## **14.1.9 Loss of External Electrical Load**

### **Accident Description**

Figure 14.1.9-4

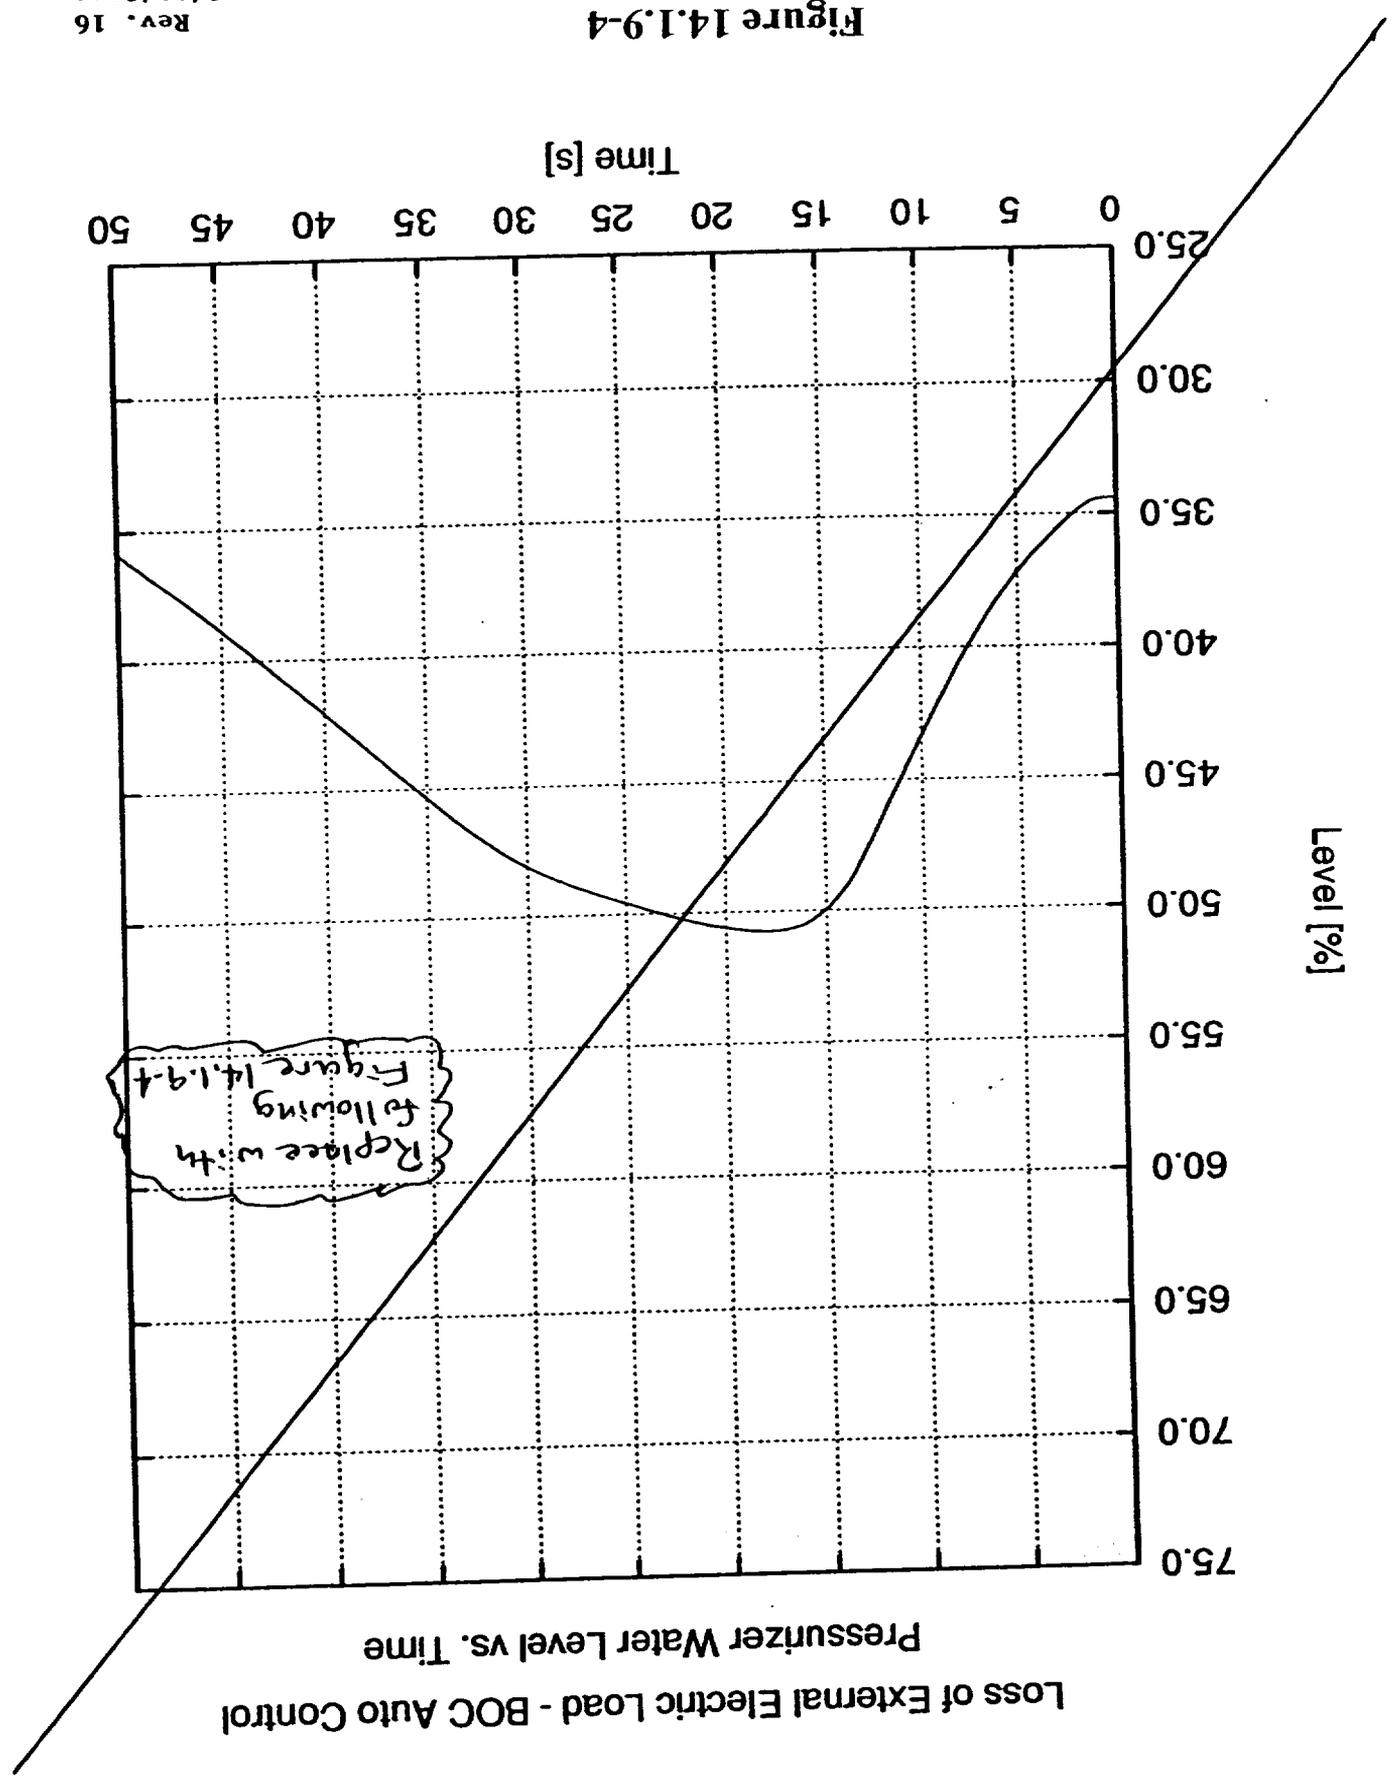
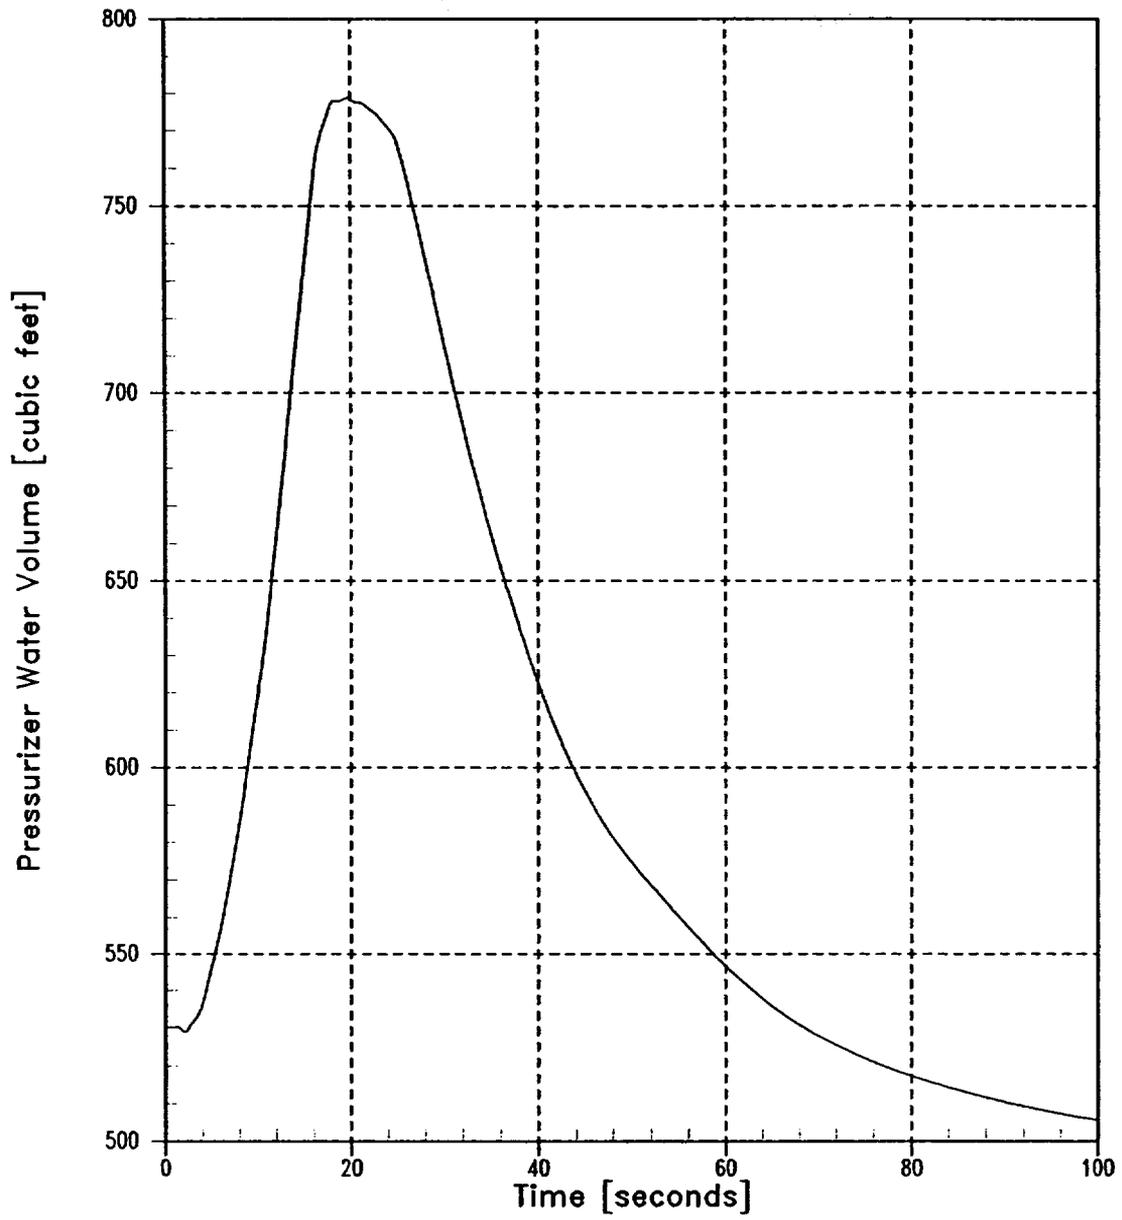
Replace with  
following  
Figure 14.1.9-4

Figure 14.2.6-2

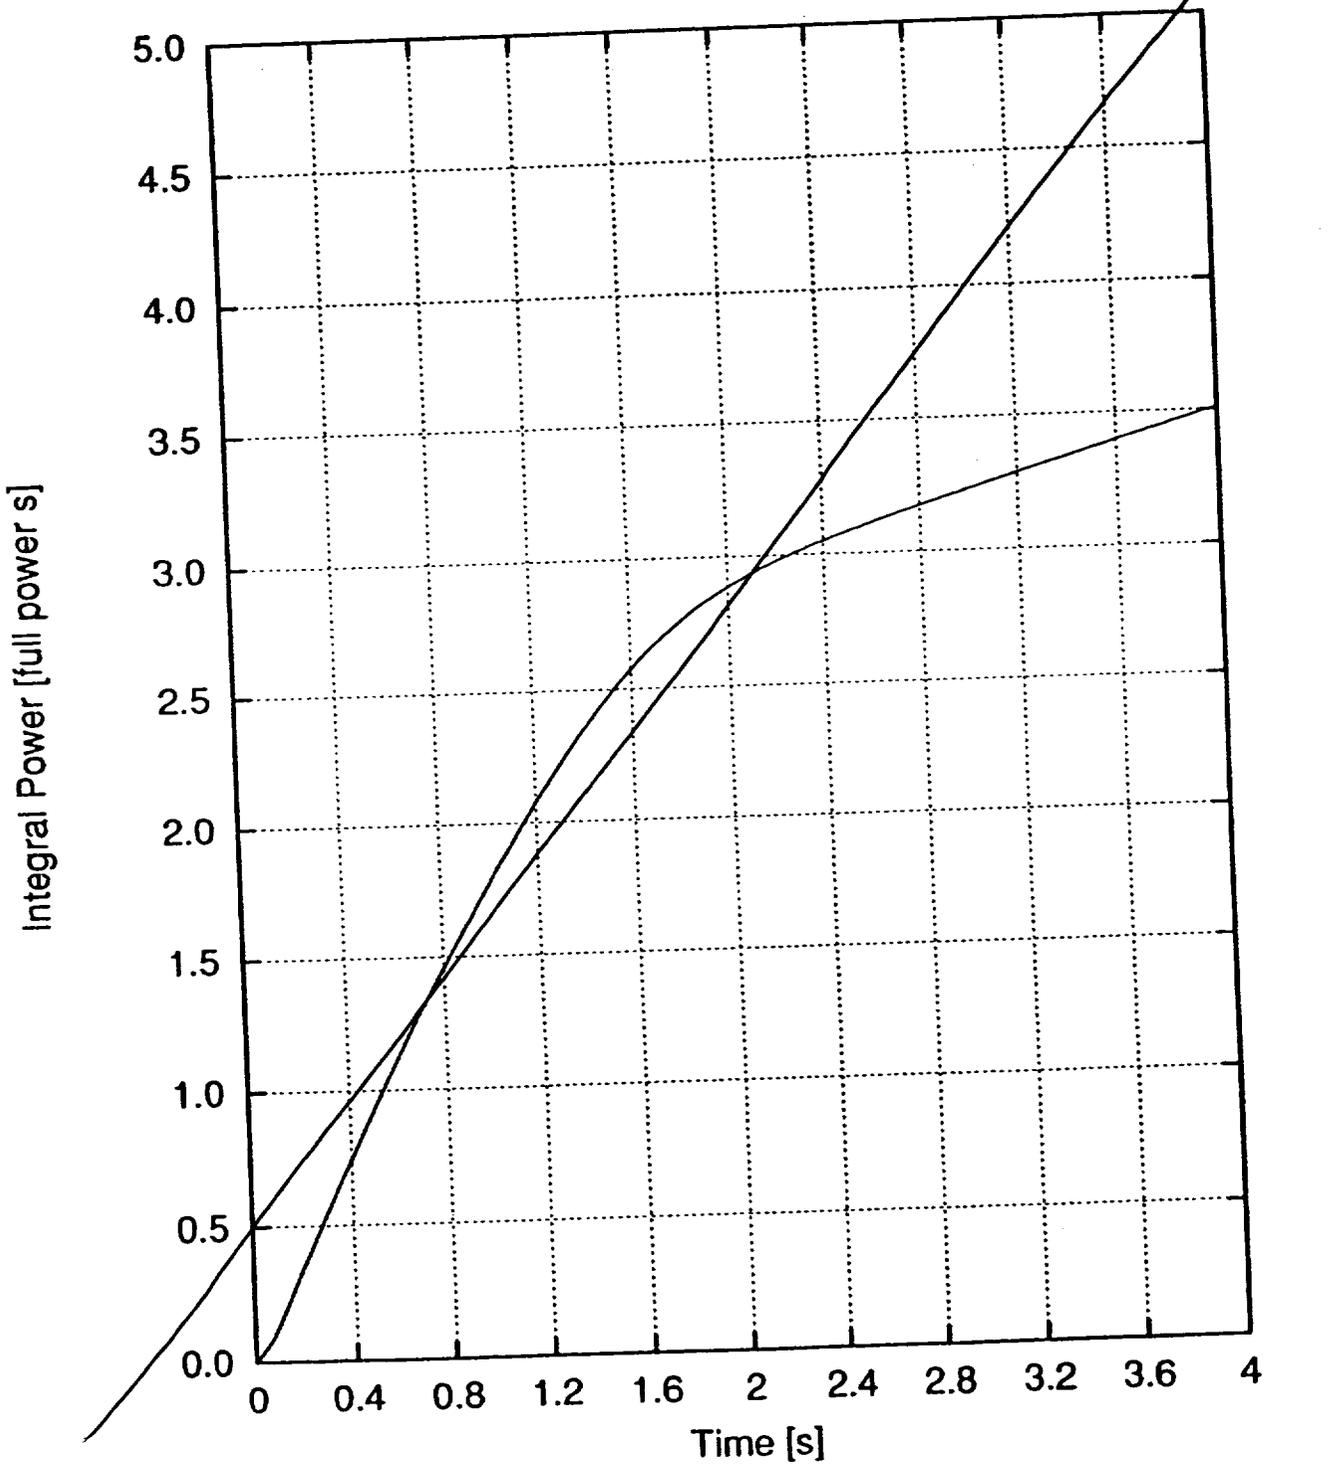
delete

FIGURE 14.2.6-4

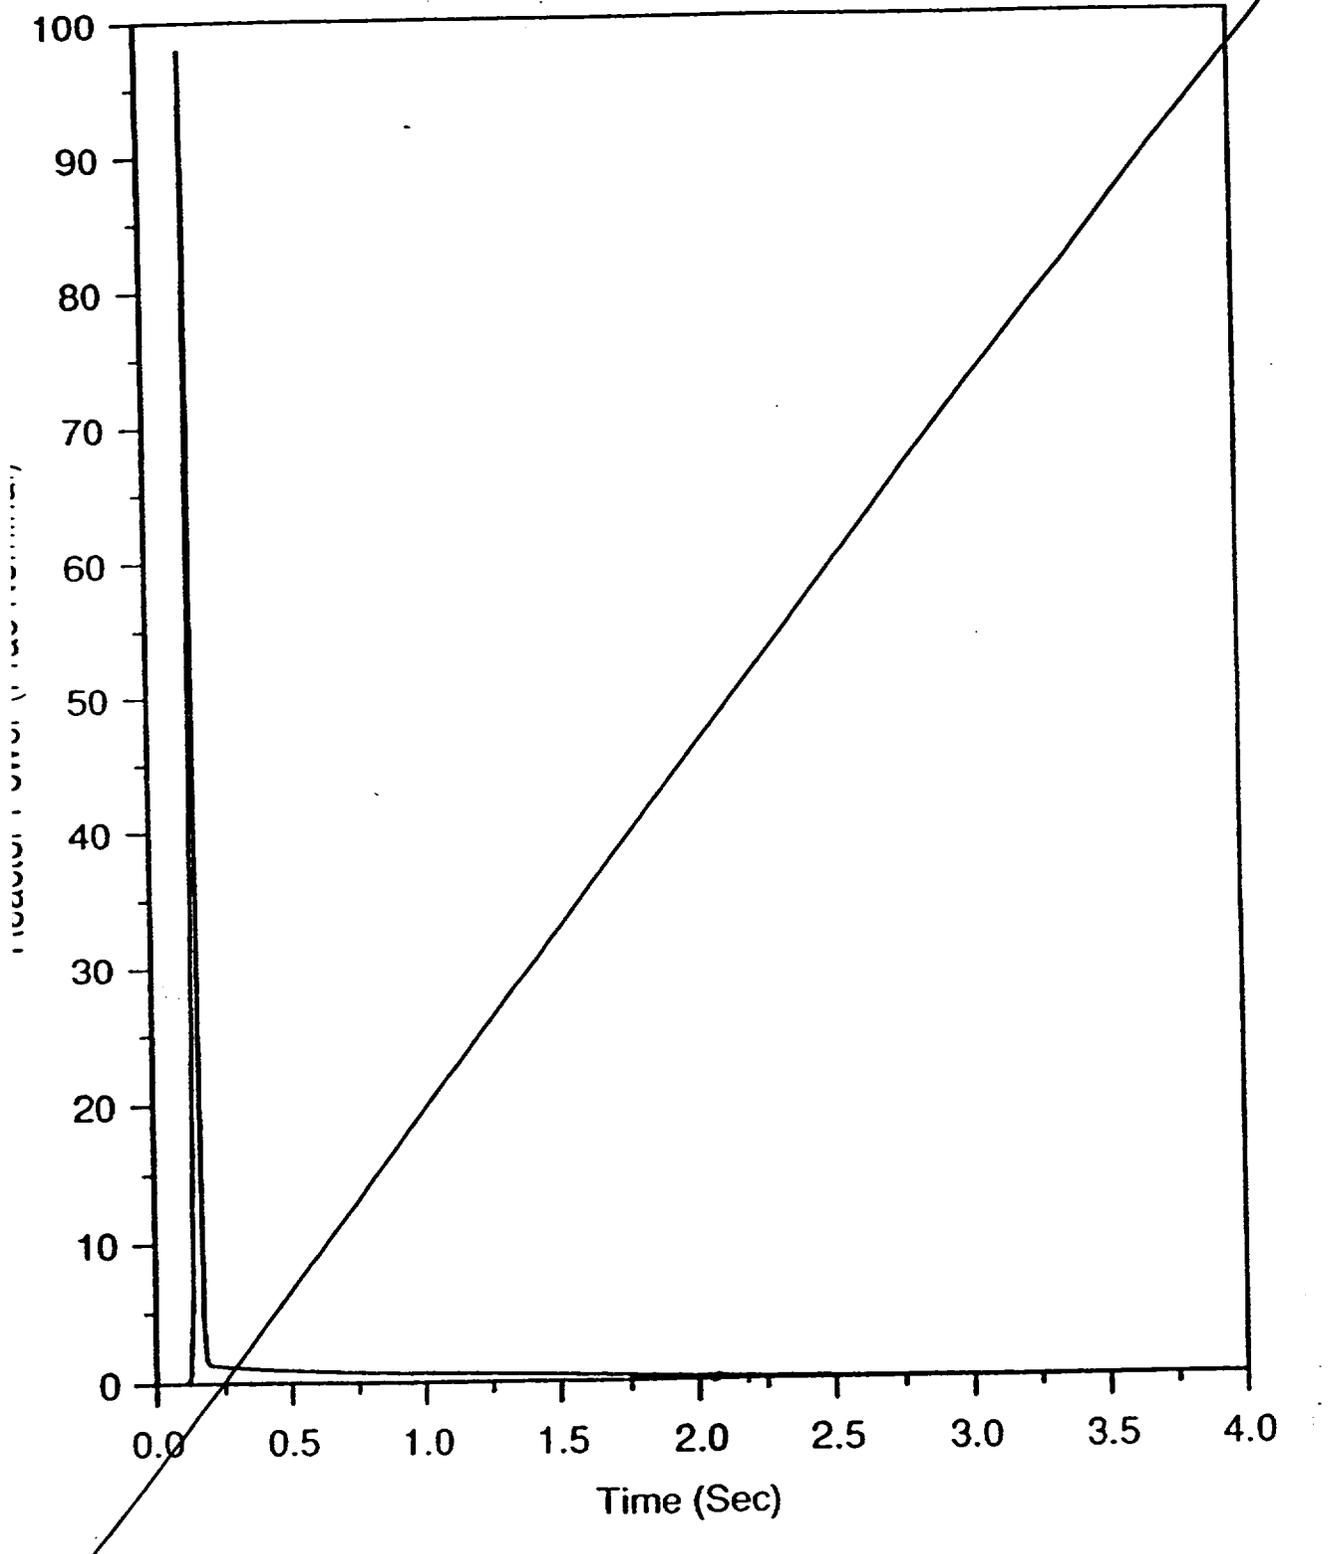
replace

FIGURE 14.2.6-5

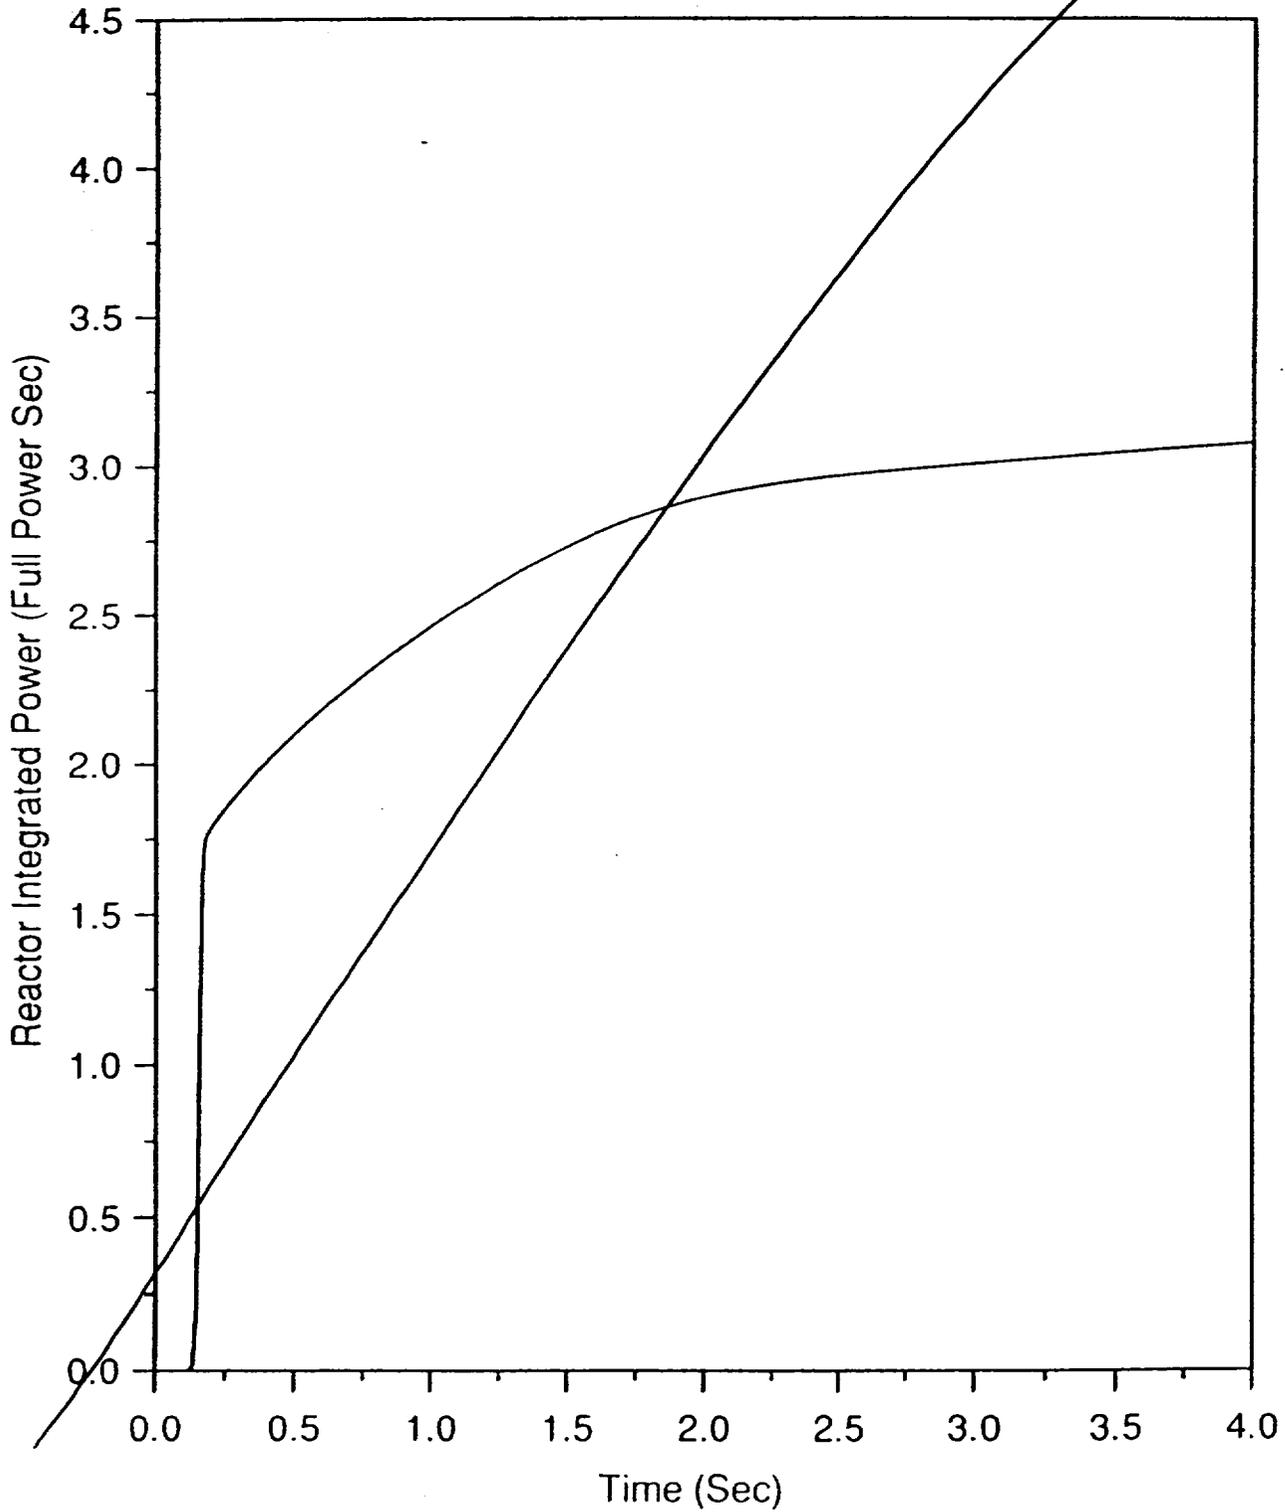
delete
